RE: Appeal of Land Use Approval for CAO23-011
October 23, 2023

CAO23-011 violates MICC for two reasons, and thus the Approval of CAO23-011 should be overturned:

Below is an illustration showing the MICC requirements that are violated by CAO23-011 :

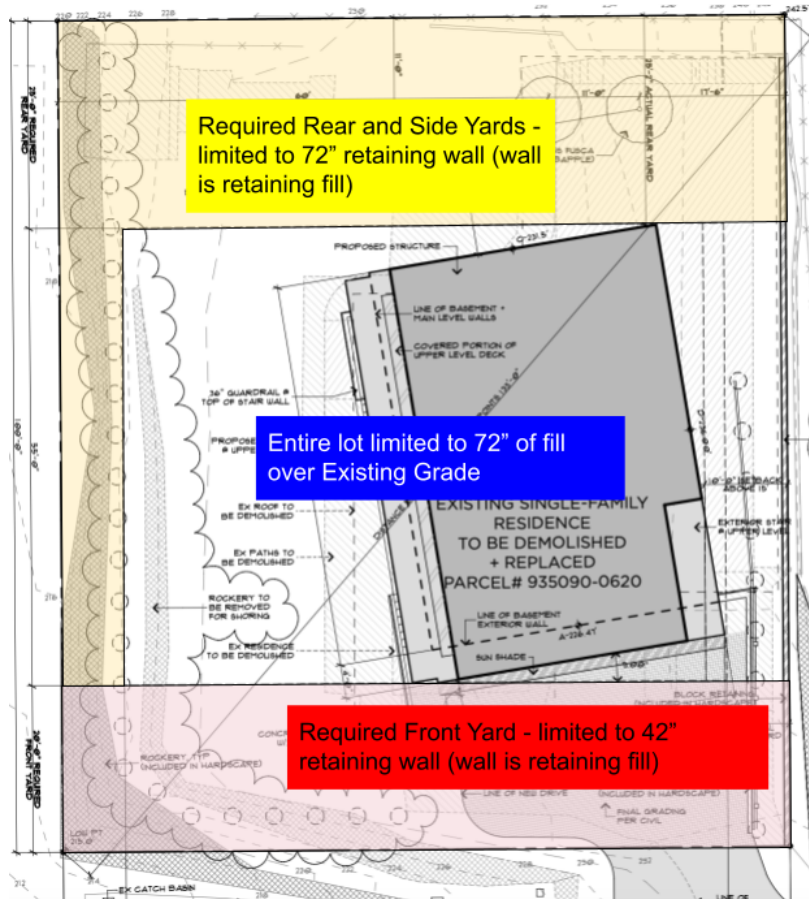
- 19.02.050(E)(1)(a)(i) - The proposed combined rockery + retaining wall for the fill slope in the western Required Side Yard and Required Rear Yard exceed the maximum allowed height of 72 inches above the lower of Existing Grade or Finished Grade. The proposed retaining wall in these yards is ~120" (Piles 23 through 37 in the table from CAO23-011 SUB2, sheet SH2 below).
- 19.020.050(E)(1)(a)(ii) - The proposed combined rockery + retaining wall for the fill slope in the Required Front Yard exceeds the maximum allowed height of 42 inches above the lower of Existing Grade or Finished Grade. The proposed retaining wall in these yards is ~120" (Piles 13 through 22 in the table from CAO23-011 SUB2, sheet SH2 below).

In order to comply with MICC regulations of retaining walls and fill, several things need to happen:

1. The heights of retaining walls containing fill in Required Yards must be reduced to 42" in the Required Front Yard, and 72" in the Required Side and Rear Yards. Note that MICC restricts the **combined** height of retaining walls + rockeries in each required yard. Therefore the remaining portions of the existing rockery and the new retaining/shoring walls must have their heights combined for comparison with MICC 19.02.050(E)(1)(a)'s requirements.
2. Fill that raised the Finished Grade to more than 72" above the Existing Grade must be removed.

Figure 1. Applicant's 2021 Survey of 6950 SE Maker showing distance from retaining wall to walkway

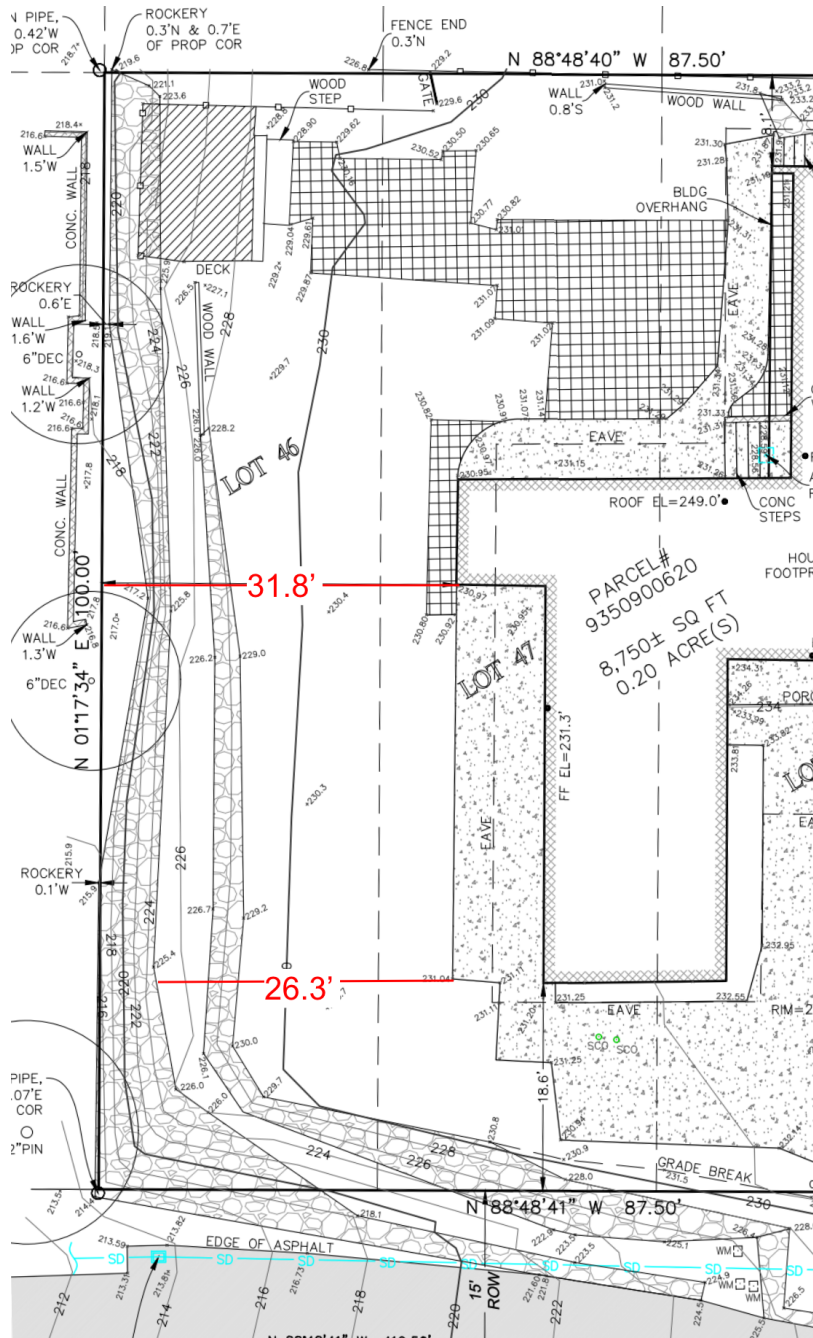
The 2021 survey of the Development Site shows the distance from the walkway on the western side of the existing house to the top and bottom of the retaining wall west of the house.

By using those same measurements on the 1963 aerial photo of the property (from the City of Mercer Island GIS), it's clear that there was no retaining wall in 1963.

Figure 4. Locations of 3 cross sections of surveys

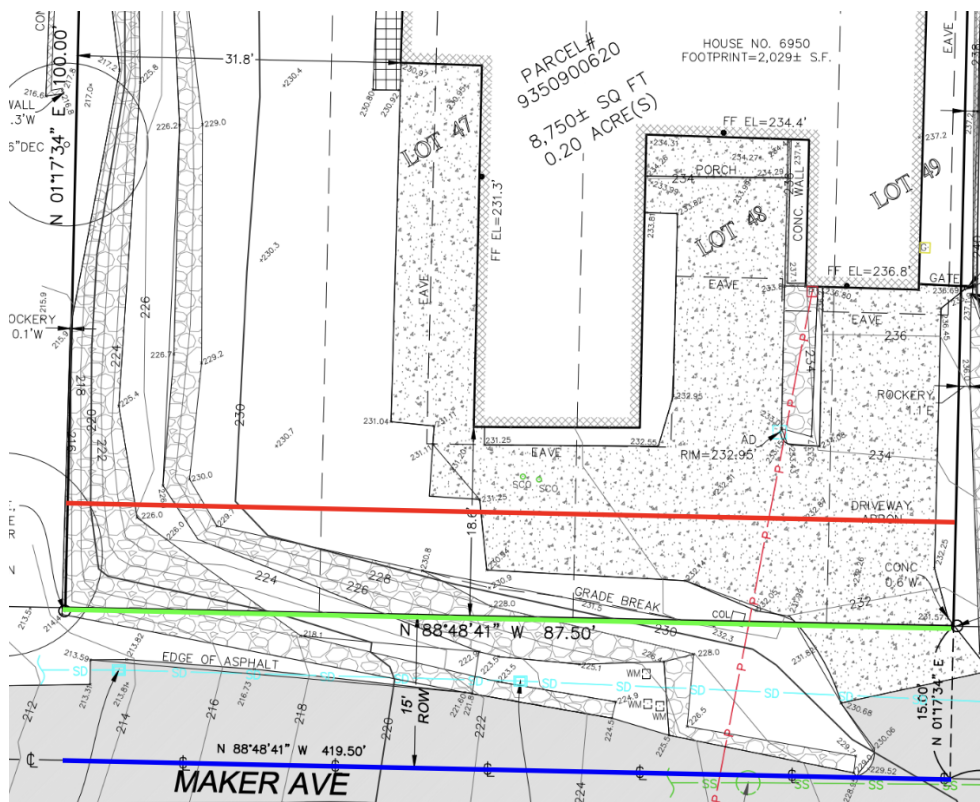
Figures 4 and 5 show comparisons between 3 east-west cross sections (shown below in Figure 4) of the 1963 Survey and the 2021 Survey. These clearly confirm that the retaining wall was installed between the dates of the two surveys. In these two surveys, 60 years apart:

- The elevation of the Maker Street midline (shown in Blue in Figure 4) differs from 1963 to 2021 by only a few inches (despite the street being paved several times between the two surveys).
- At the south boundary of 6950 (in Green in Figure 4), the retaining wall that was added is clearly visible - there are up to 4 feet of difference between 1963 and 2021.
- The cross section 10' north of the boundary (in Red in Figure 4) shows that the retaining wall increased the elevation of the yard by 7.5 feet when comparing 2021 and 1963 elevations.

Figure 5. Comparison of cross sections of 1963 and 2021 Survey elevations²³

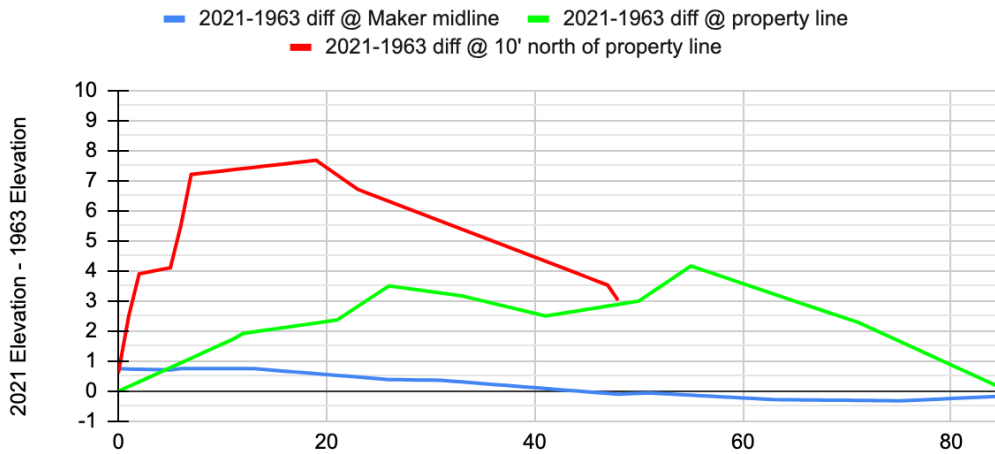
It is clear from these cross sections that the retaining wall's installation occurred after the 1963 aerial photos were taken for the City.
